RE: HCPS Roye-Williams Elementary School – HVAC Systemic / Plumbing Renovation (CAG 20-1)

**ADDENDUM 1**  
FEBRUARY 24, 2020

HVAC SYSTEMIC / PLUMBING  
RENOVATION  
ROYE-WILLIAMS  
ELEMENTARY SCHOOL

**S104**

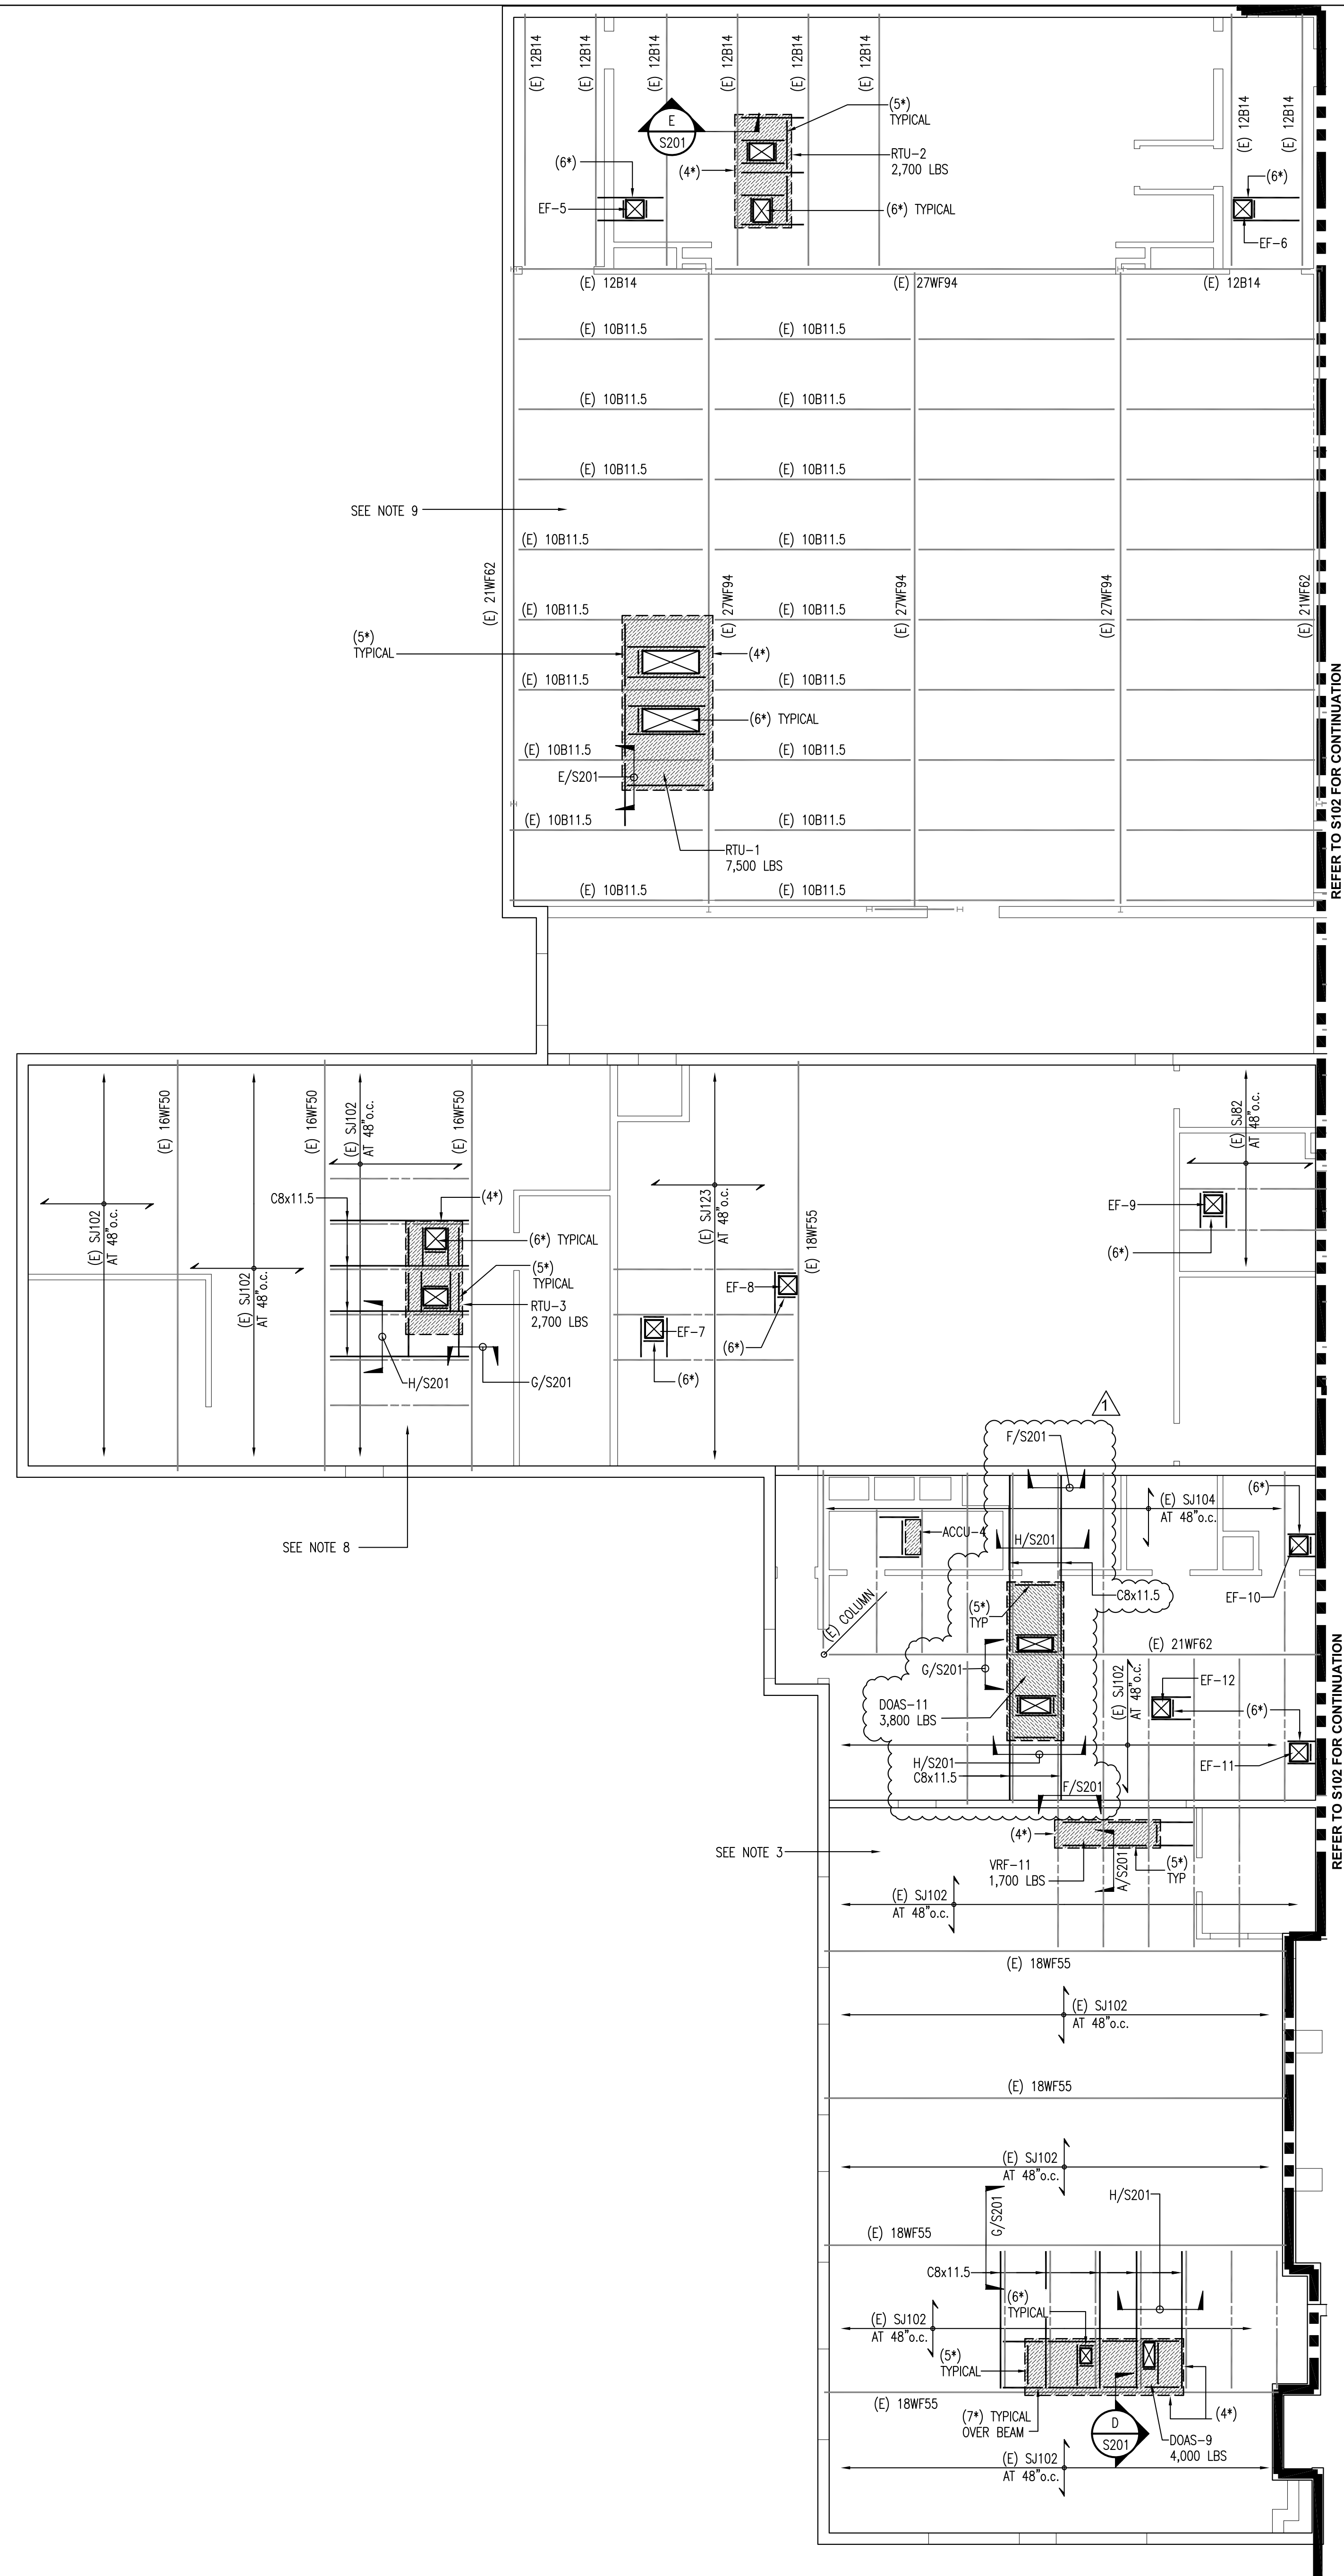
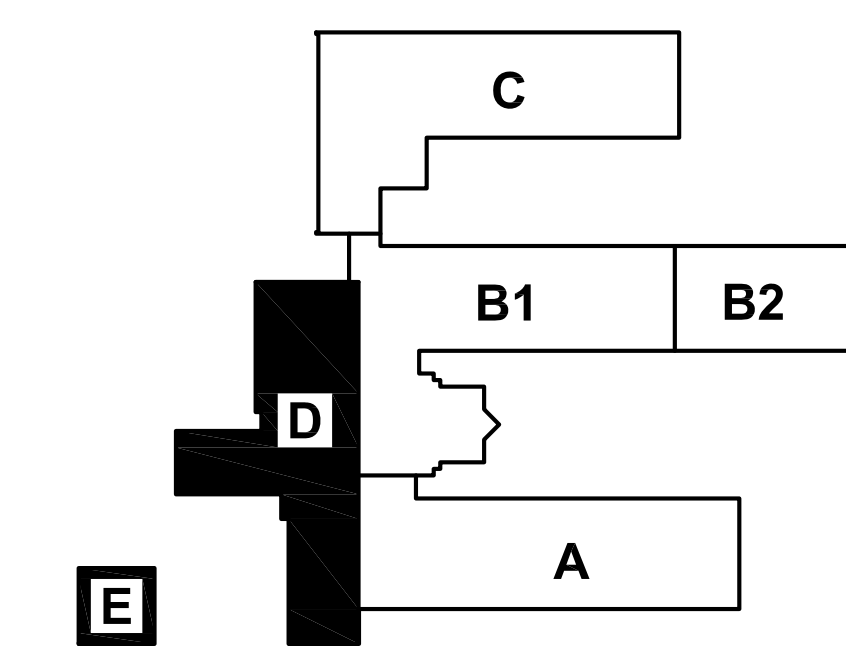
- S104: Replace previously issued drawing with the attached.
- A104: Add wall type 2.13 in east corner of Storage 407 directly behind the corridor water cooler. Wall shall extend approximately 2’-6” in length (full length of wall behind water cooler) and shall be used as a chase for plumbing piping serving water cooler and adjacent toilet room.

**E205**

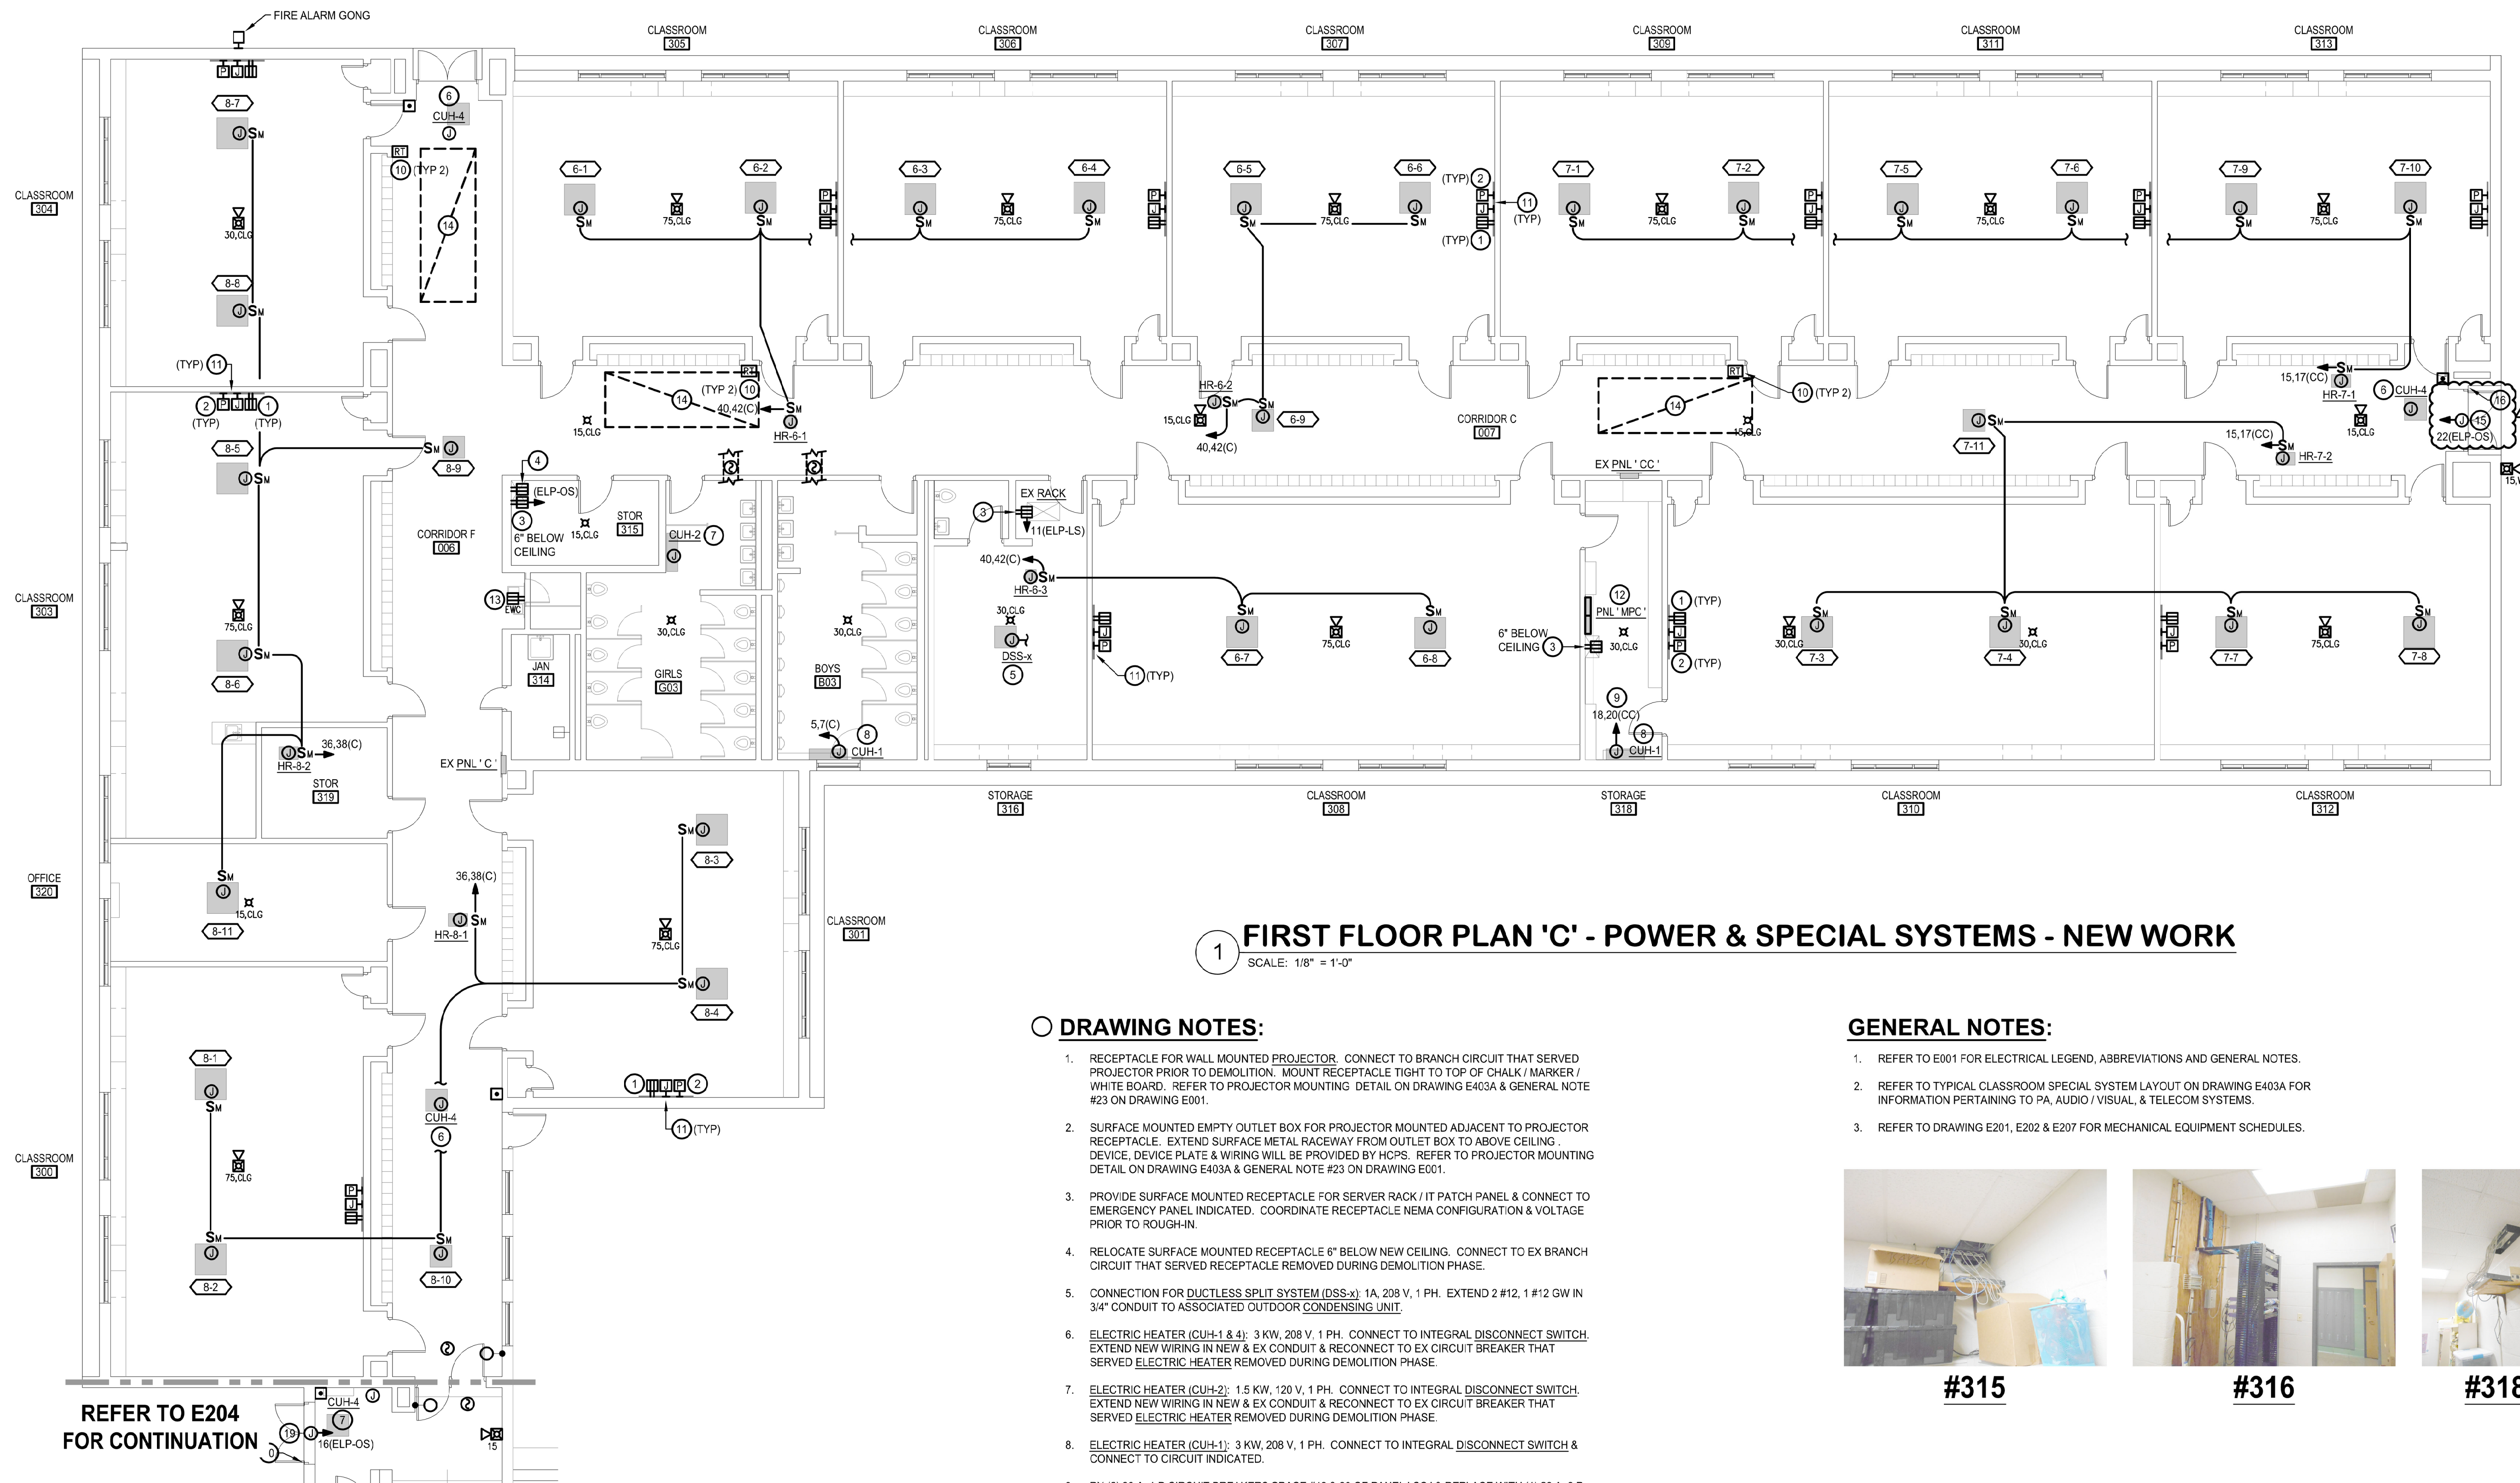
- E203: Replace previously issued drawing with the attached.
- E204: Replace previously issued drawing with the attached.
- E205: Replace previously issued drawing with the attached.
